Broadcast Products Technical Bulletin 94-007R

Subject: CORRECTING FLICKER AND SMEAR

Model: BVM-1310/1311/1315/1316/1316C

BVM-1910/1911/1912/1915/1916/2811

Figure 1

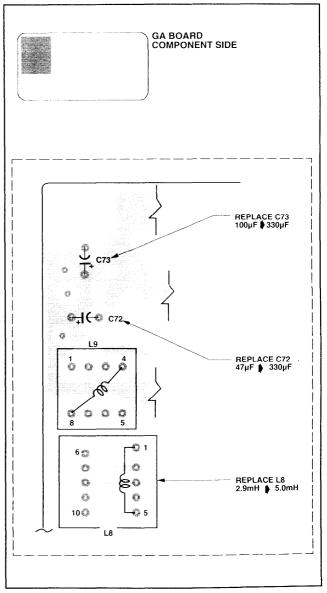
When the ±150V input current is reduced, resulting in lowered brightness, some flicker and smear may occur. Additionally, a noise stripe may appear on the screen. To correct these conditions, perform the following modification procedure.

GA Board, Component Side (See Figure 1.)

- 1. Open board cover.
- 2. Replace L8 with new 5.0mH choke coil.
- Replace C72, C73 with new 330µF electrolytic capacitors.
